## **Suffolk County Council**

**Response to the Targeted Consultation 2025**

**Norwich to Tilbury (EN020027)**

Targeted Consultation

**SUFFOLK LOCATION REFERENCE 3  
FOR TARGETED CONSULTATION 2025  
COMPARED WITH STATUTORY CONSULTATION  
2024**

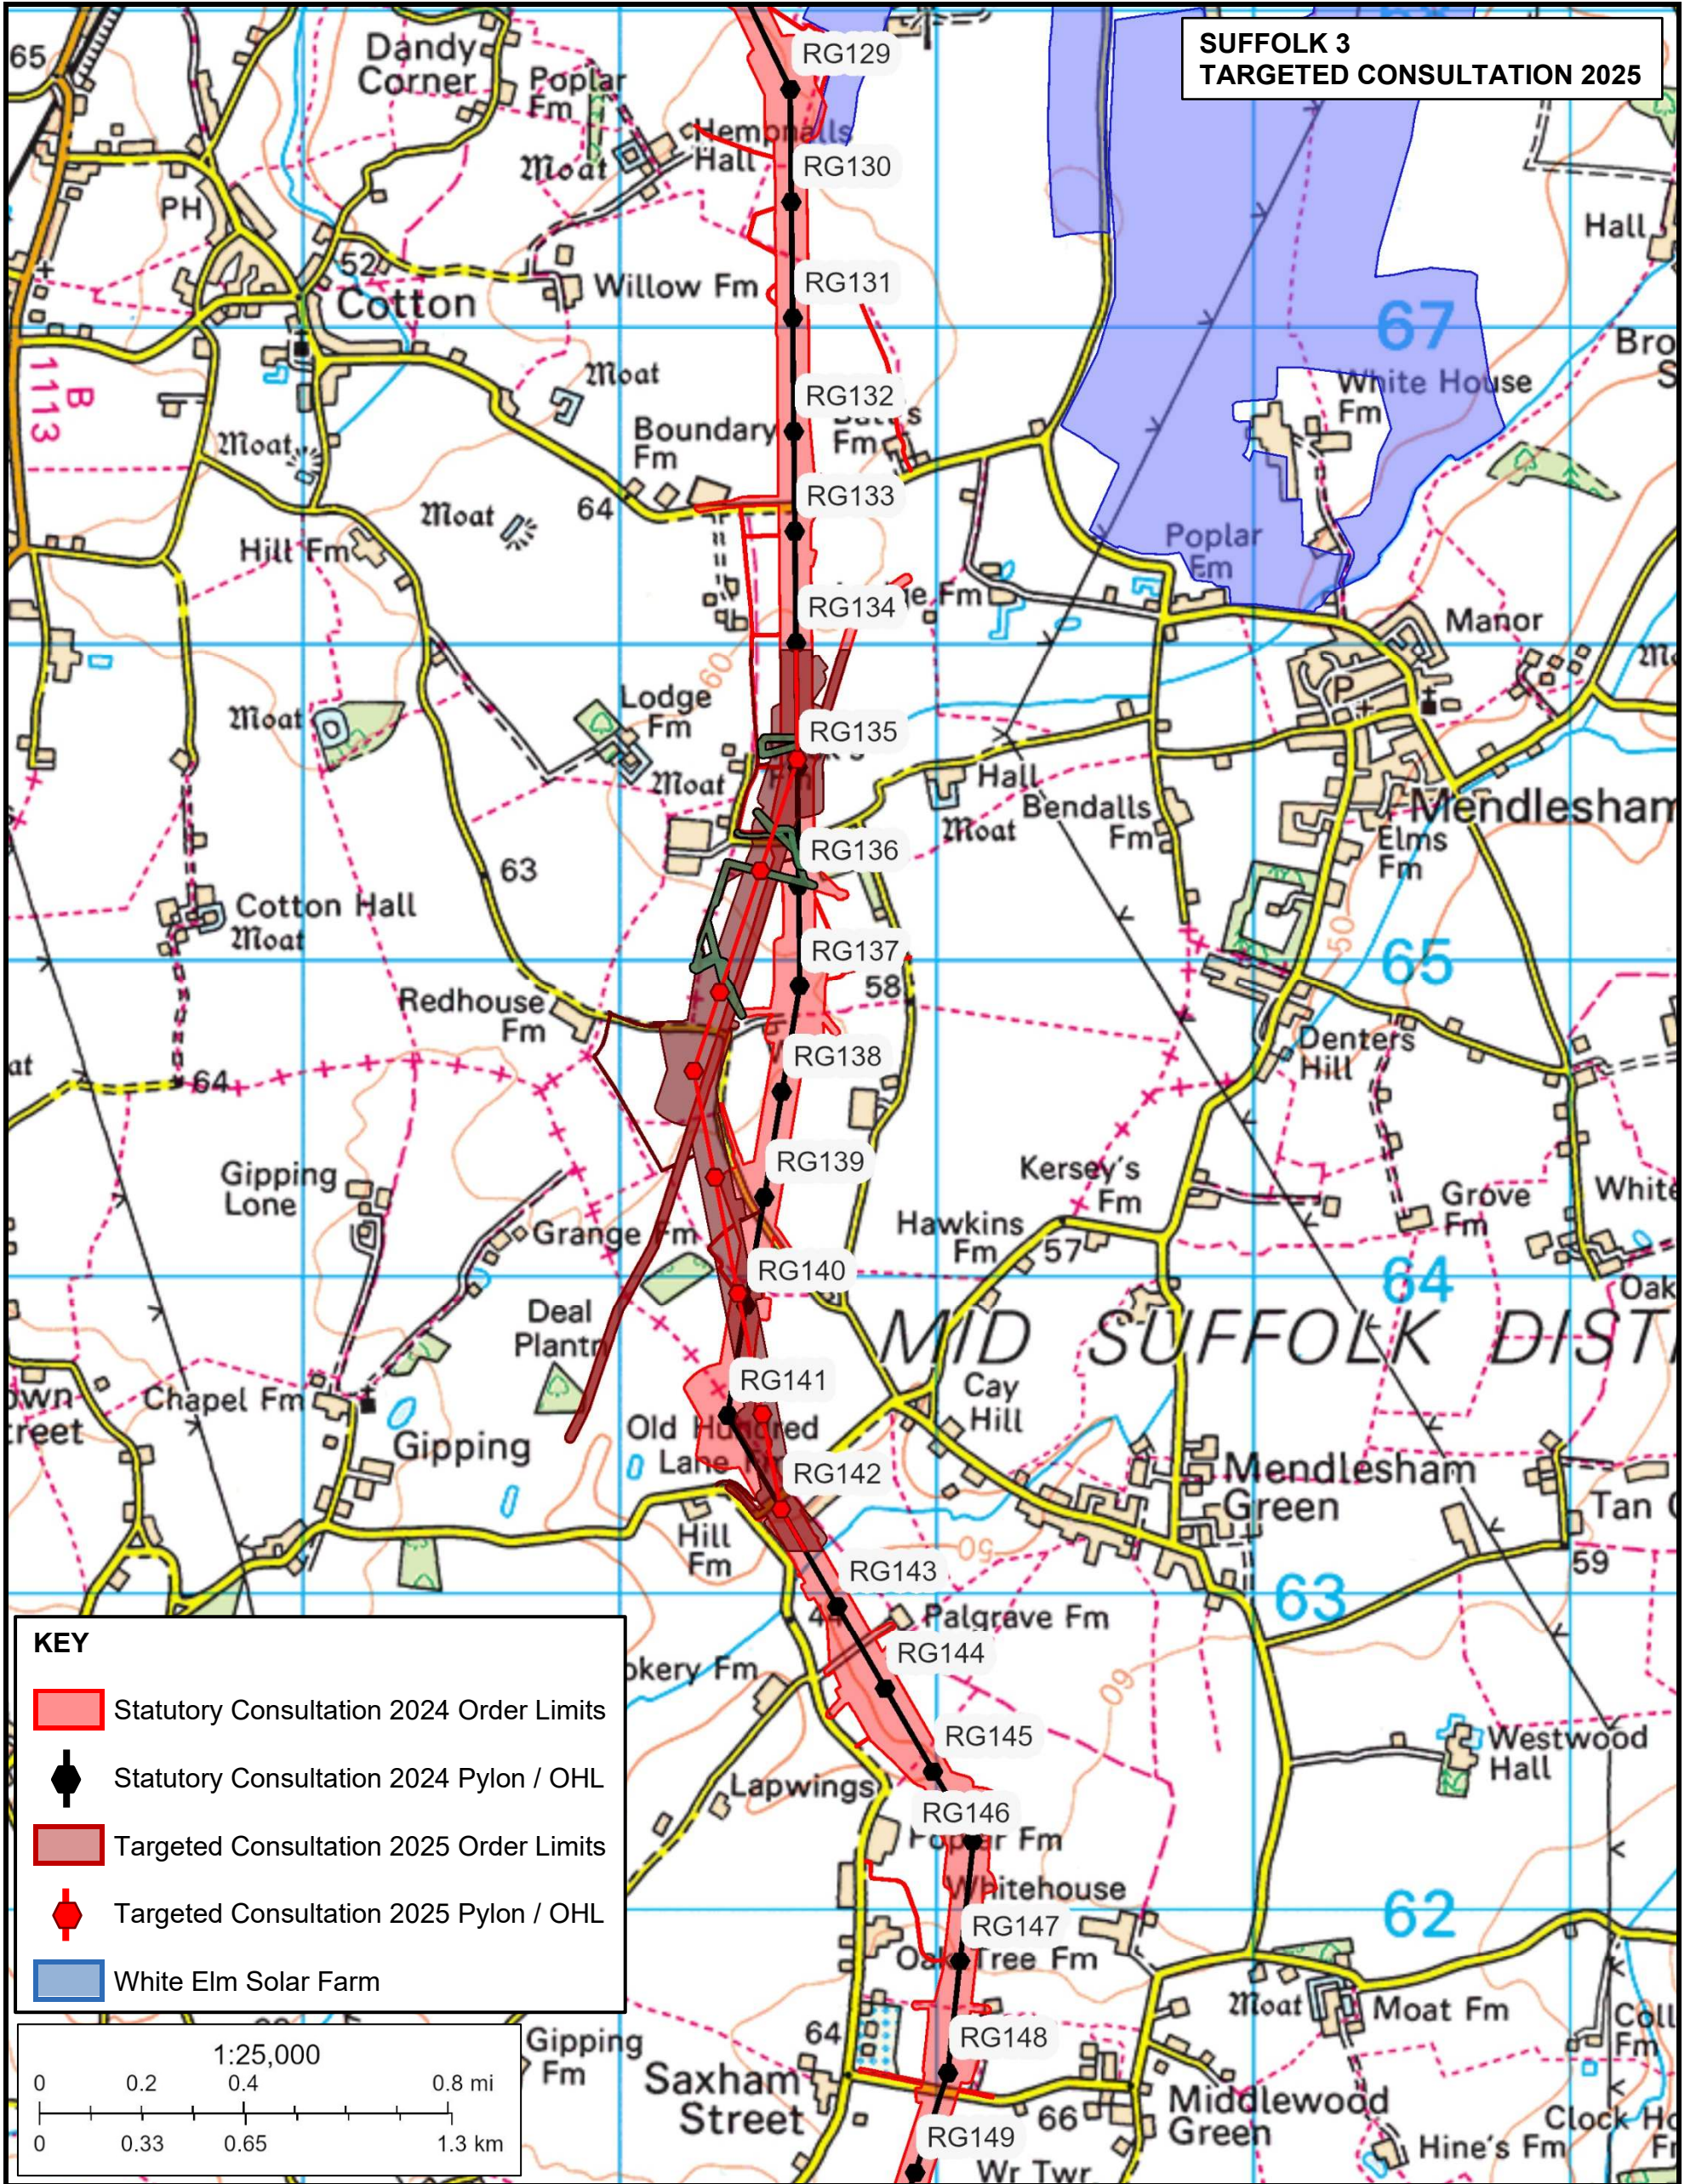
- 2.14. In brief, SCC understands that the proposal at this location is to move a line of pylons near Cay Hill to the west of the location proposed at statutory consultation, between pylons RG136 and RG142 (previously at statutory consultation RG135 to RG141).
- 2.15. SCC welcomes the proposed changes, in principle, as they would remove the alignment further from some residential properties and lessen the effects on some views in this area.
- 2.16. SCC also welcomes the reduction in tree loss and avoidance of the area of "perceived" ecological interest.
- 2.17. Based on currently available information there are no major changes for archaeology based upon the information within the HER.
- 2.18. PROWs appear to be used as access roads (near to Wicks Farm W-392/060/0) and the Middy Railway promoted route at red house farm Footpath W-

392/045/0 & Cotton Boat W-203/056/0. This will require mitigation to ensure that safe use by all users. This should be outlined and safety adequately addressed in a PROW management plan.

- 5.8. SCC Ecology welcome the reduction in tree loss and avoidance of the area of “perceived” ecological interest.
- 5.9. In regard to:
- “use field edges to route diversions for lower voltage electricity lines to reduce potential effects on an area of perceived ecological interest
  - use field edges or existing tracks for temporary and permanent works access where practicable.
  - To accommodate this proposed change, we are also proposing to reposition the haul road and the bellmouths.”
- 5.10. It must be ensured that surveys have previously covered or will cover these areas and impacts on “field edges” and other locations described above, have been/will be comprehensively assessed with regard to potential impacts on important habitats and species associated with these features e.g. arable margins and hedgerows.

- 8.4. The relocation of the haul road crossing to the west on the unnamed road to Elden Lanes Farm places it closer to the sharp bend but more detail such as scaled plans would be needed to allow the authority to comment further.
- 8.5. Moving the bellmouth on Lamberts Lane appears to place it close to the sharp bend when Wible Lane joins but more detail such as scaled plans would be needed to allow the authority to comment further.

- 9.18. SCC Landscape welcomes the proposed changes, in principle, as they would remove the alignment further from some residential properties and lessen the effects on some views in this area.

- 9.19. The closer alignment of haul roads is welcome, in principle, but care would need to be taken that they are at a safe distance from existing vegetation and would not incur any additional vegetation losses.

- 9.20. It is not fully clear what impacts and effects the relocation of the bellmouth at Lamberts Lane will have on vegetation losses. SCC considers that this would need to be fully assessed.

- 9.21. It would be important to ensure that the wooded area to the west of the line (between RG137 and RG138, new alignment) is at a sufficient distance to the line as not be adversely affected.

- 9.22. At RG142 (new alignment) additional vegetation loss is likely to occur, which would need to be fully assessed.

- 10.6. No separate PROW Category is listed on the document, as requested in previous responses.
- 10.7. PROWs appear to be used as access roads (near to Wicks Farm W-392/060/0) and the Middy Railway promoted route at red house farm Footpath W-392/045/0 & Cotton Boat W-203/056/0. This will require mitigation to ensure

that safe use by all users. This should be outlined and safety adequately addressed in a PROW management plan.

- 10.8. Pylon RG141, W-392/041/0 Footpath appears to be in close proximity to PROW. The report does not mention/address/mitigate the relocation to potentially impact on the PROW.

**SUFFOLK 4  
TARGETED CONSULTATION 2025**

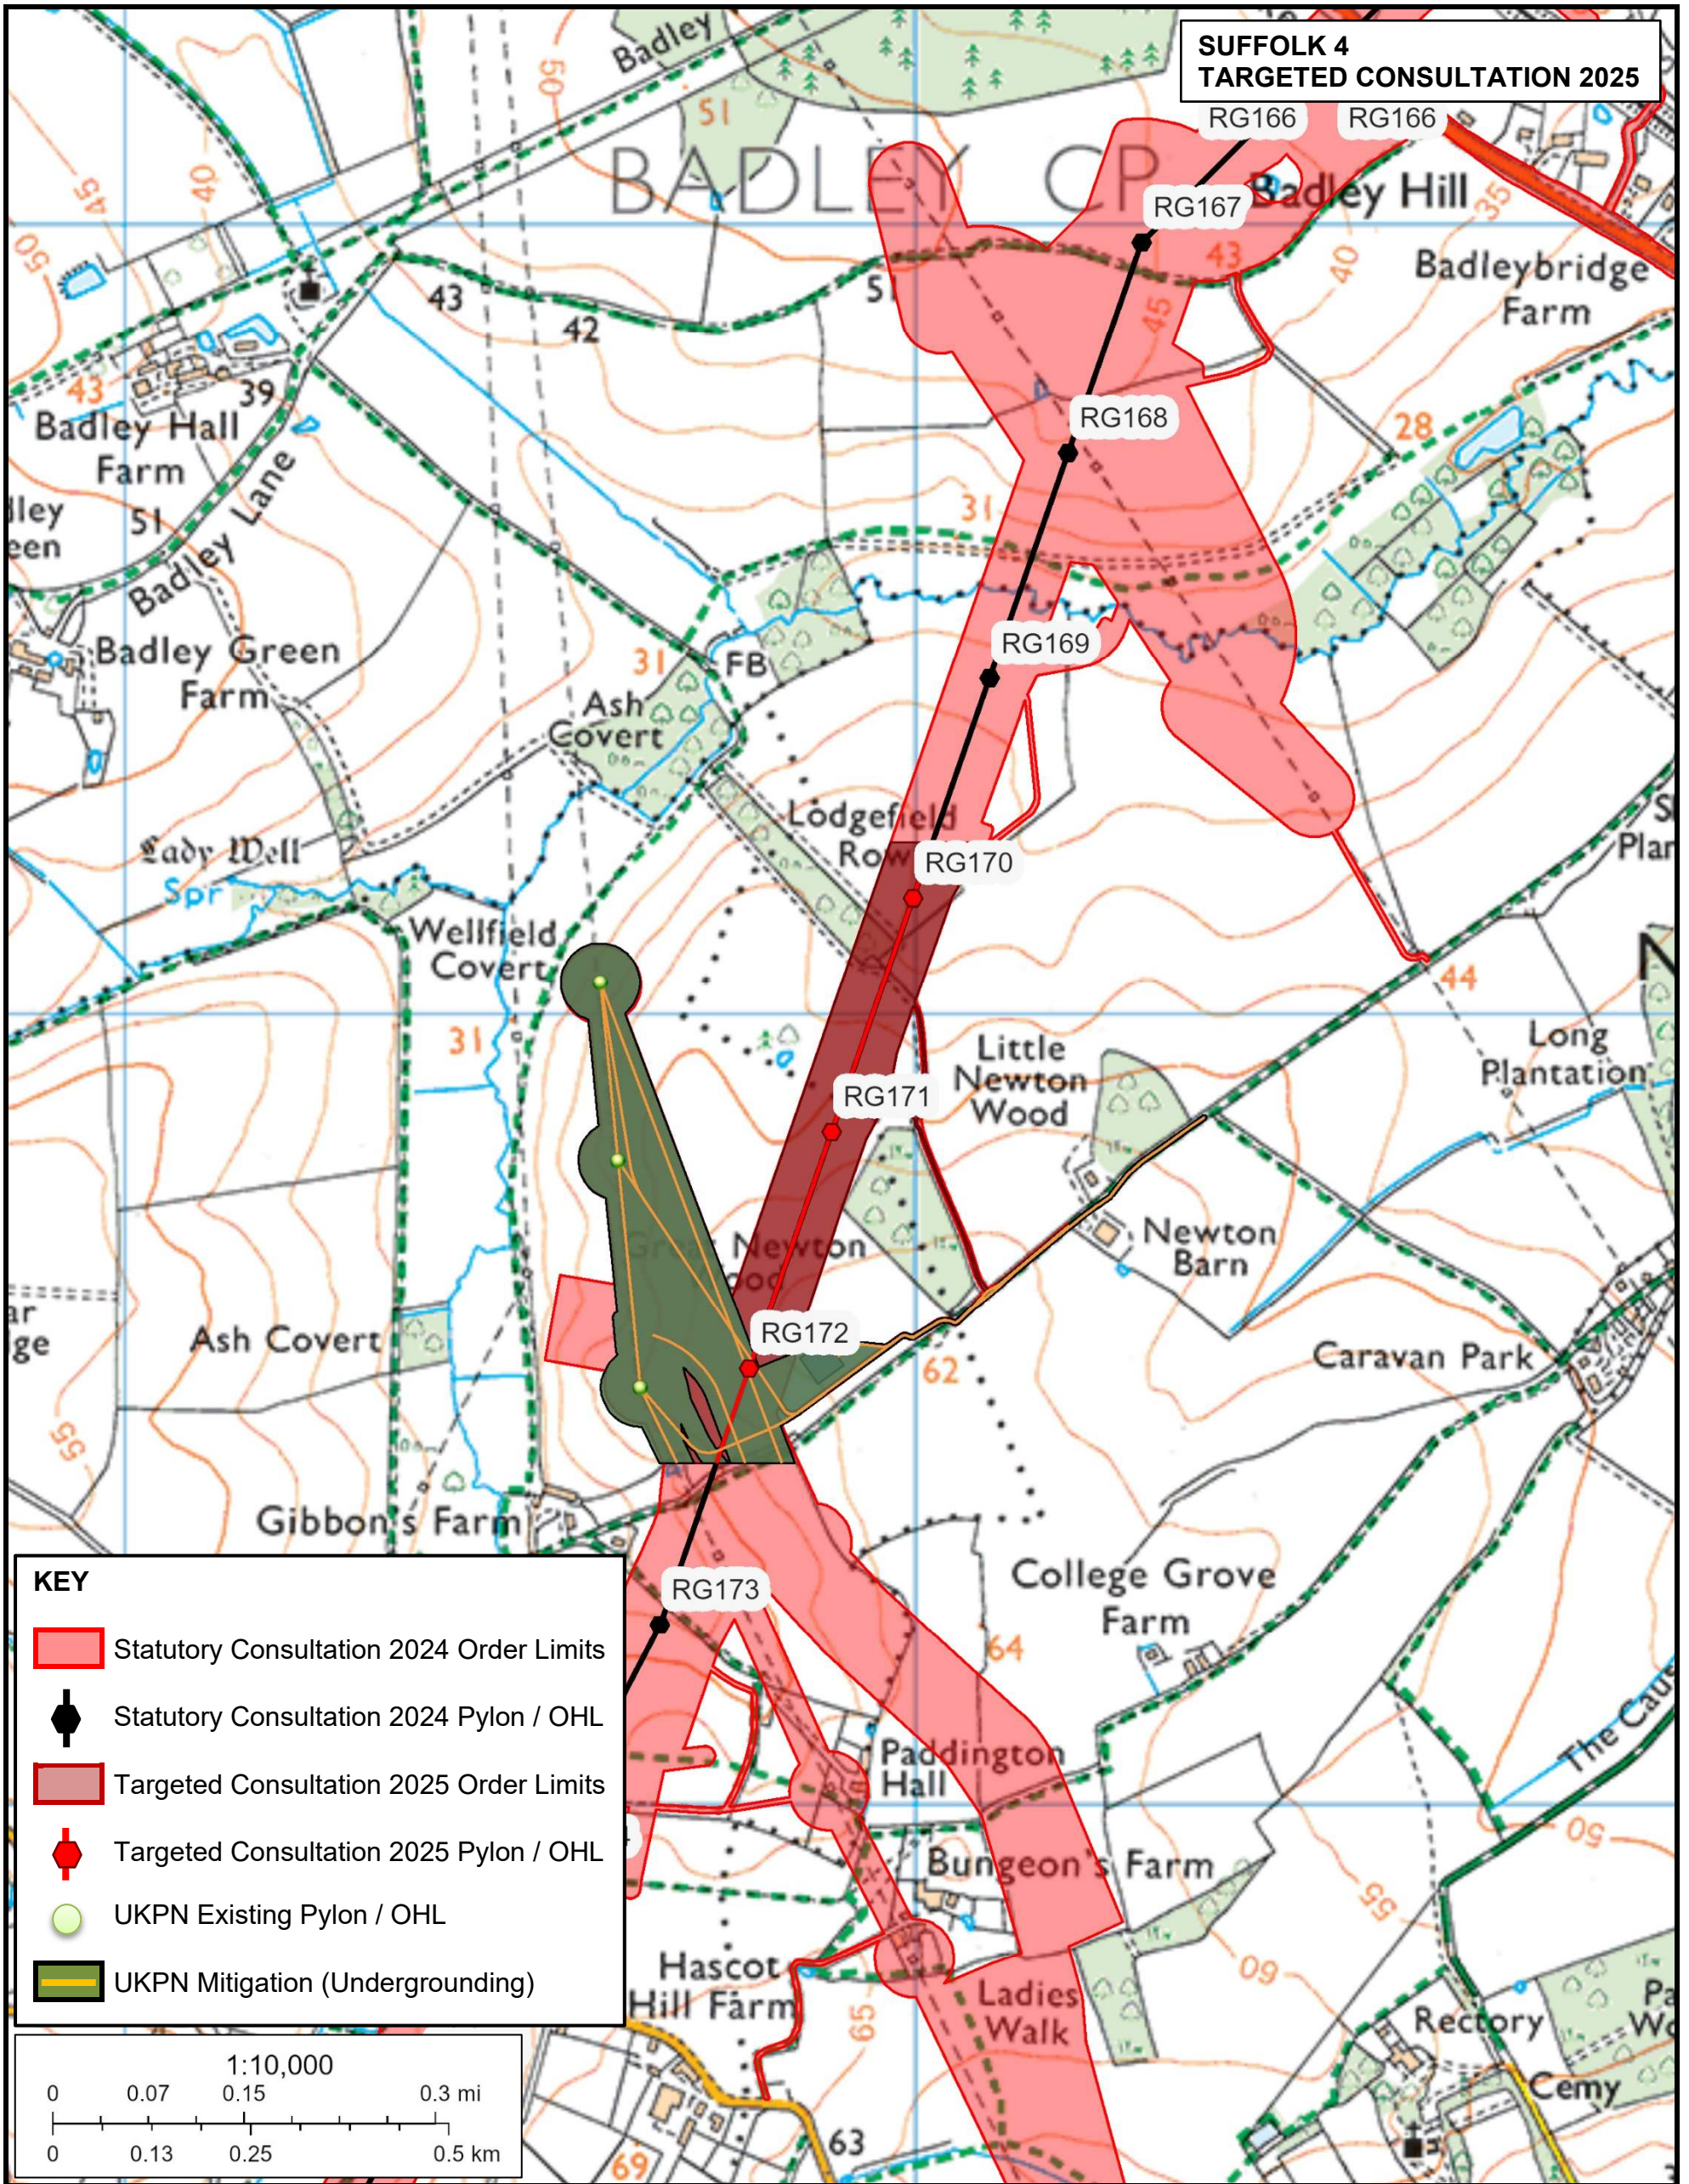
- 2.19. In brief, SCC understands that the proposal at this location is for a new construction compound nearby pylon RG173 (previously at statutory consultation RG172).

- 2.20. SCC notes that provided that the compound is set back sufficiently from any existing vegetation and that existing vegetation is appropriately protected, and provided that the vehicles using the access road would not require additional vegetation removal, the additional construction compound is acceptable in landscape terms.

- 2.24. Whilst the construction compound is described as temporary, it is suggested there could be Public Health impacts deriving from the positioning and use of this additional compound that have not been considered in the PEIR.

- 5.11. SCC Ecology concur with this assertion and await the updated baseline information, as indicated in the Environmental Implications of Change - Suffolk 4 document, if these changes are carried forward.

- 8.6. Hill House Lane from immediately south of Barn Field Drive is a private road albeit it is a public footpath. The extended order limits do not appear to extend to the adopted highway limits. The highway authority would seek assurances that the safety of PROW users is not compromised. It is noted that there is a residential development under construction adjacent to Hill House Lane which may require consideration in the environmental assessment.

- 9.23. Provided that this compound is set back sufficiently from any existing vegetation and that existing vegetation is appropriately protected, and provided that the loads using the access road would not require additional vegetation removal, the additional construction compound is acceptable in landscape terms. SCC expects that the existing trees along the access route (in particular those of Little Newton Wood and Great Newton Wood, but also single trees along the route) would be circumvented and appropriately protected and that any space requirements would be accommodated on the southern, arable side of the track.

- 11.2. SCC Public Health notes the addition of a temporary 132 KV construction compound near RG173 and that the Environmental Implications of Change (EIC) does not include a table analysis for the change detailing the Environmental Topics, comments and observations. The EIC concludes that this proposed change would not materially change the conclusions that were reported within the PEIR. Whilst the construction compound is described as temporary, it is suggested there could be Public Health impacts deriving from the positioning and use of this additional compound that have not been considered in the PEIR.
